REQUEST FOR PLANNING COMMISSION ACTION

Meeting Date:		October 12, 2023					
Item Name:		September 7th, 2023 Planning Commission Meeting Minutes					
Originating Department:		Community Development					
Presented by:		Lane Braaten					
Previous Commission Action (if any):							
Item Type (X only one):	Consent	X	Regular Session		Discussion Session		
RECOMMENDATIONS/COUNCIL ACTION/MOTION REQUESTED <i>(Include motion in proper format.)</i>							
Motion to adopt the September 7th, Planning Commission Meeting Minutes							
EXPLANATION OF AGENDA ITEM <i>(Include a description of background, benefits, and recommendations.)</i>							
<u>Attachments:</u> 1. September 7 2023 Planning Commission Minutes							
FINANCIAL IMPLICATIONS:							
Funding Sources & Uses:							
Budget Information:							
_____ Budgeted							
_____ Non Budgeted							
_____ Amendment Required

CITY OF WACONIA
September 7, 2023

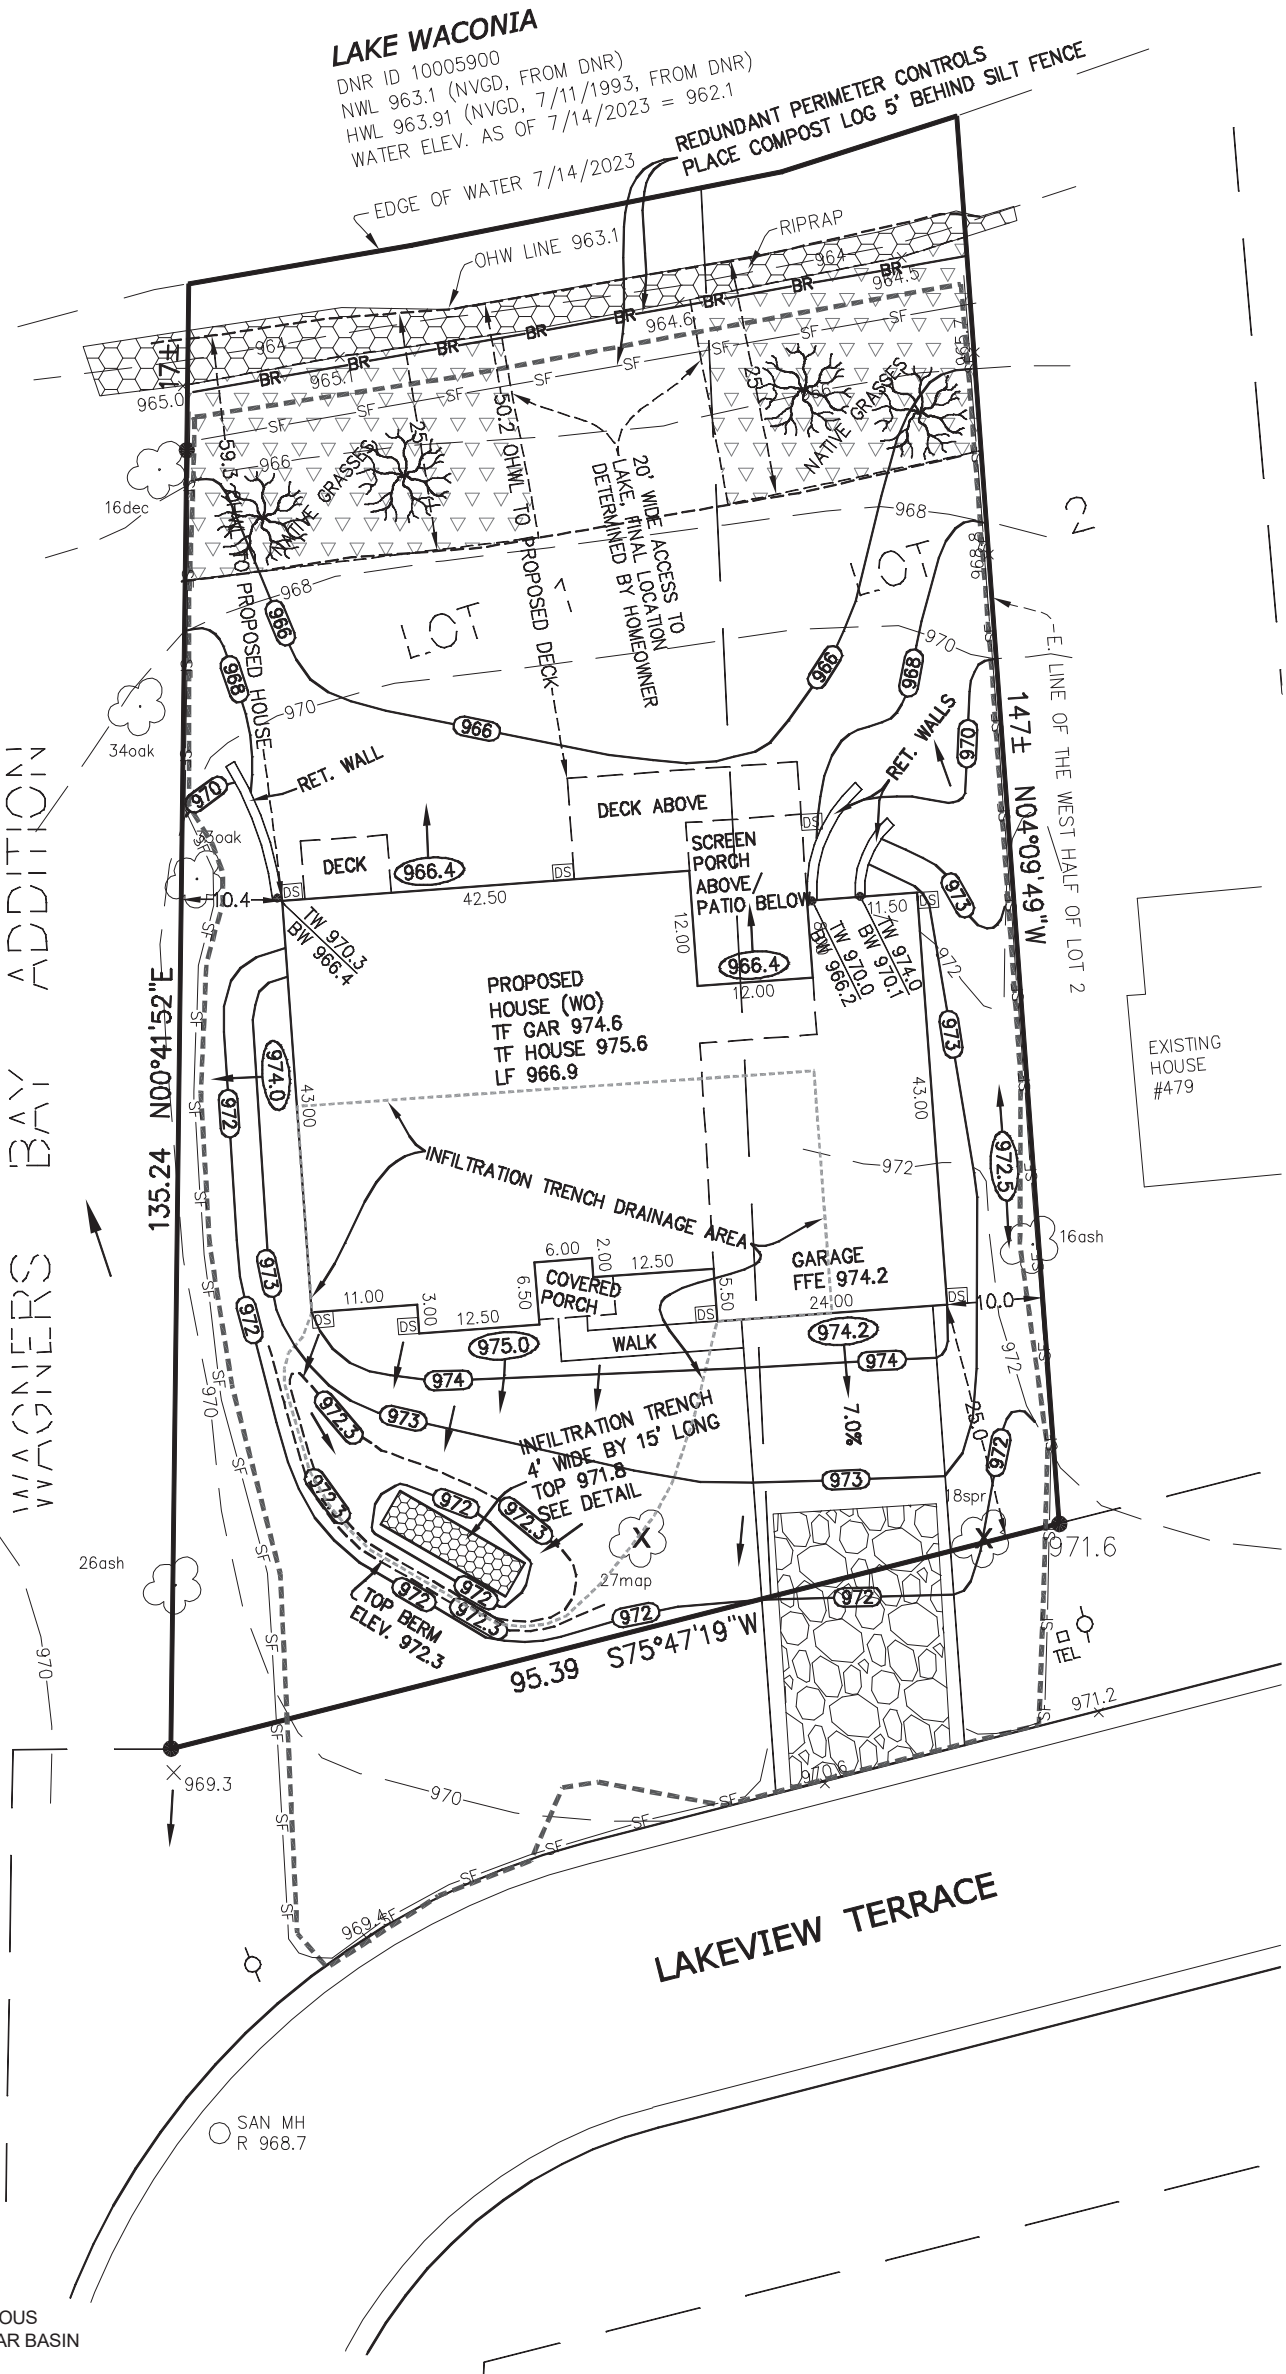
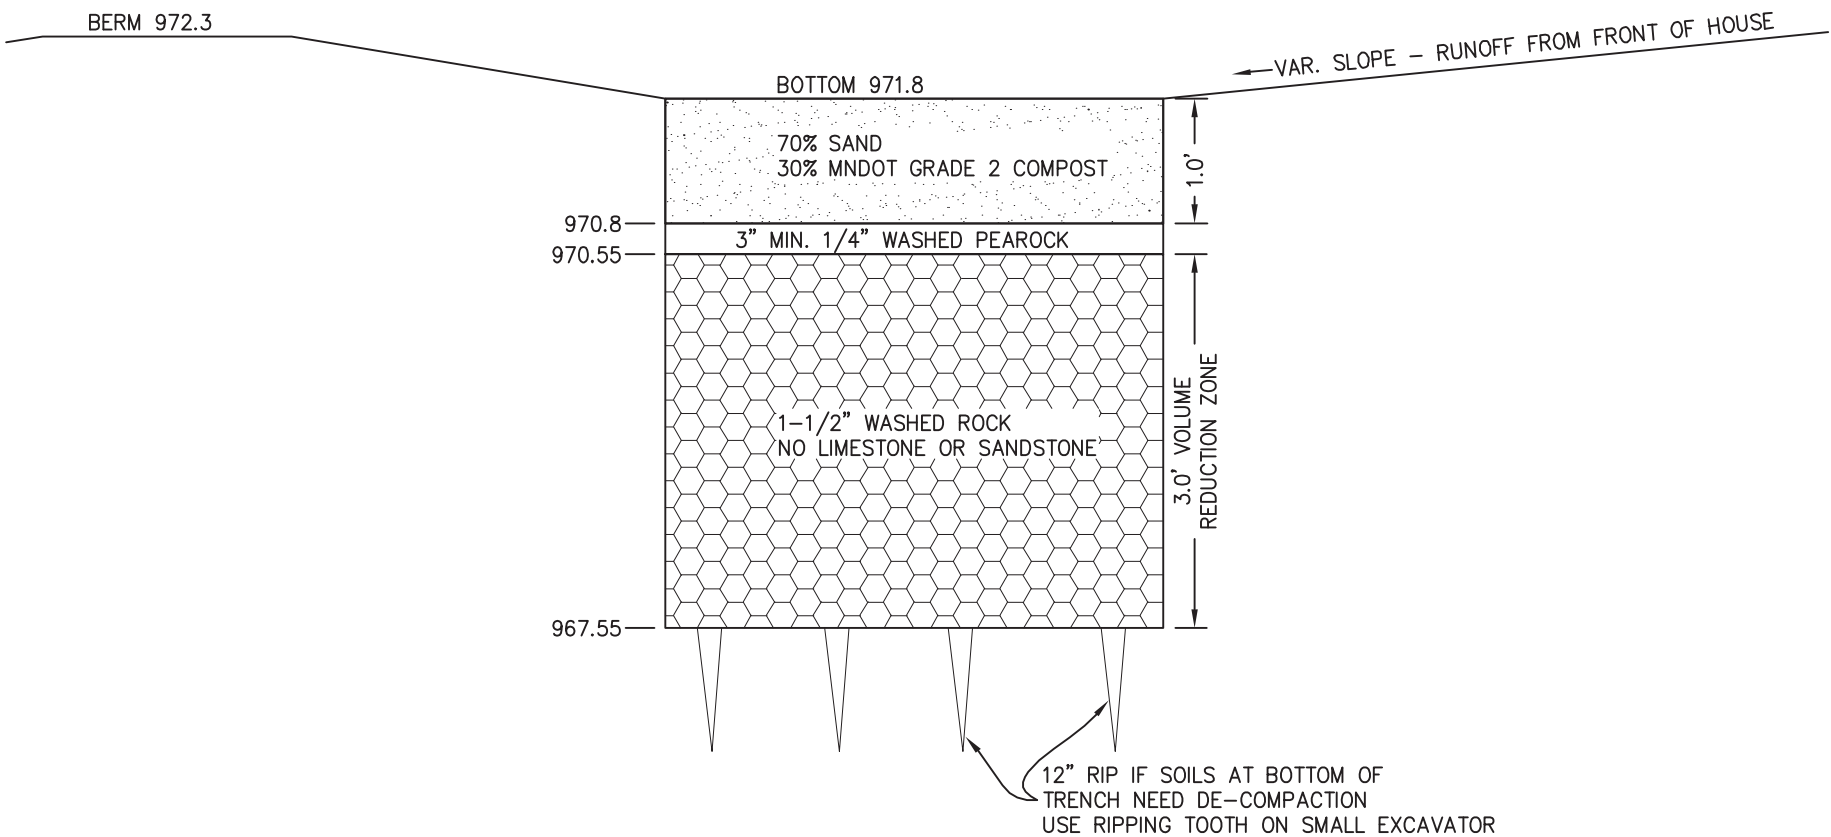
I used the WMO's stormwater calculator that we make available to applicant's to demonstrate compliance with our rules. There are two proposed practices on the site that provide stormwater treatment: the infiltration trench and the native shoreline buffer. There are similar BMP types in the WMO's calculator: infiltration and disconnected impervious.

The calculator shows that the infiltration trench (entered as infiltration) and native shoreline buffer (entered as disconnected impervious surface) are sized to provide enough treatment for the **proposed increase** in impervious surface to meet WMO rules (see first image).

The treatment features don't provide full treatment for the all impervious on the site (see second image), but do provide increased treatment over the existing condition.

If the Planning Commission chooses to recommend approval, staff recommends including the following conditions:

1. Due to the large site disturbance for construction of a new home, perimeter control shall be provided along the lake side of the project.
2. The applicant shall submit and install a landscape plan at the time of permit application that details the restoration of the shoreline with native and/or natural vegetation to provide habitat, functional soil stability and vegetative screening from view from public waters to the satisfaction of the Community Development Department and Carver County Soil & Water Conservation District.
3. The applicant shall provide the City with cash, corporate surety bond, approved letter of credit or other surety satisfactory to the City to guarantee the proper installation and growth of the approved plans.
4. Final installation of the storm water plan shall meet the satisfaction of the City Engineer.

ATTACHMENT 1: PROVIDED SURVEY & DETAIL

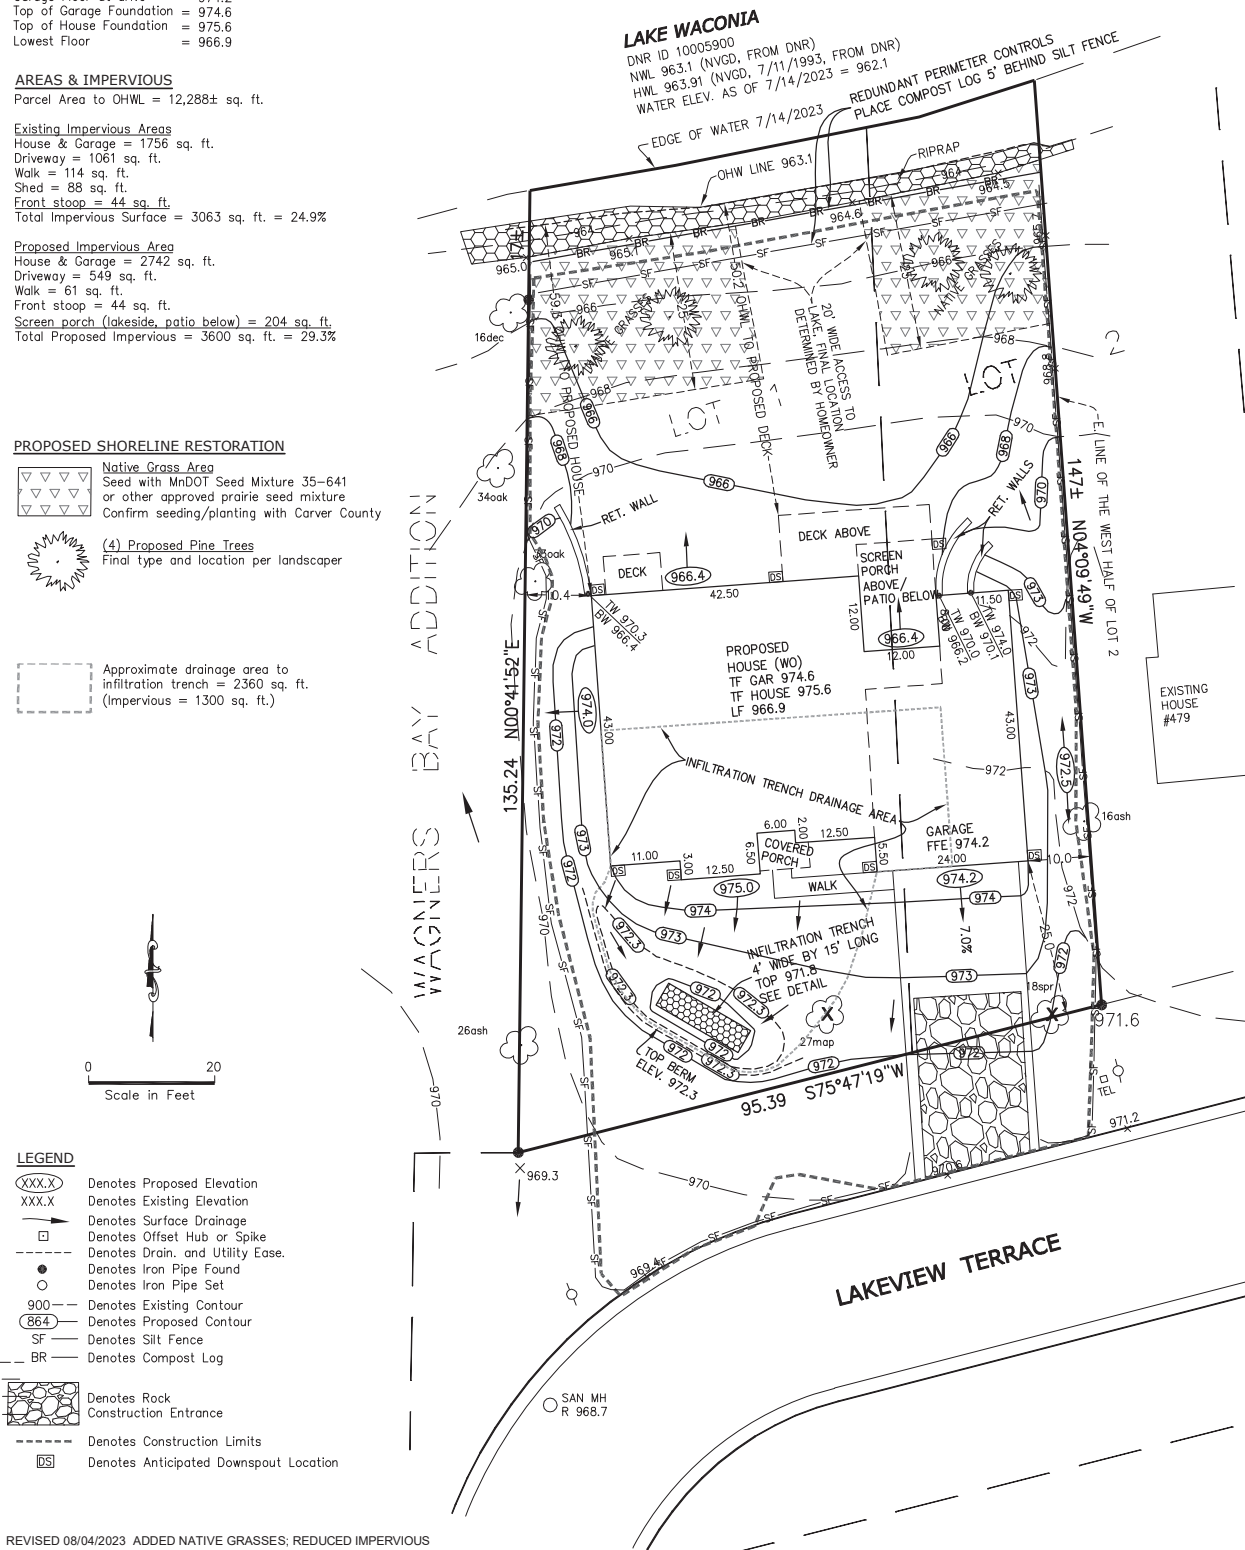
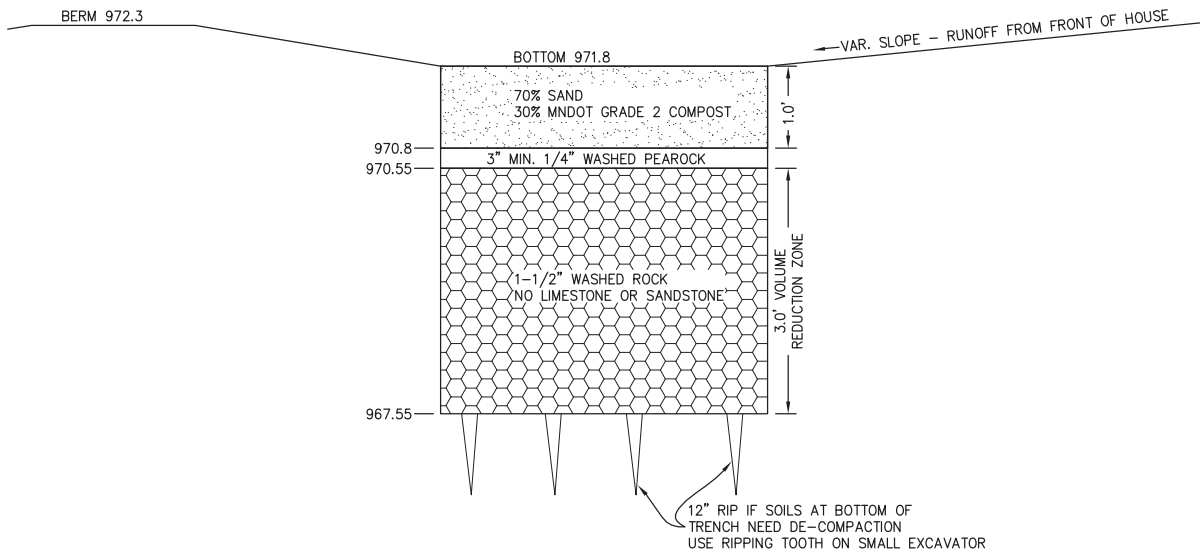
Under proposed conditions, there is a net increase of 537 SF impervious area (see survey for additional detail). Assuming a water quality volume of 1 IN of runoff over the net new impervious area would indicate a volume reduction standard of 45 CF. If we assume the higher MIDS standard of 1.1 IN over the impervious area, the volume reduction standard would be 49 CF.

On the north side of the property, a significant portion of the existing turf is to be replaced with deep rooting native grasses consistent with Carver County seeding/planting standards. This provides a substantially improved hydrologic condition, represented by increasing the hydrologic soil group of the amended area by one step to HSG A.
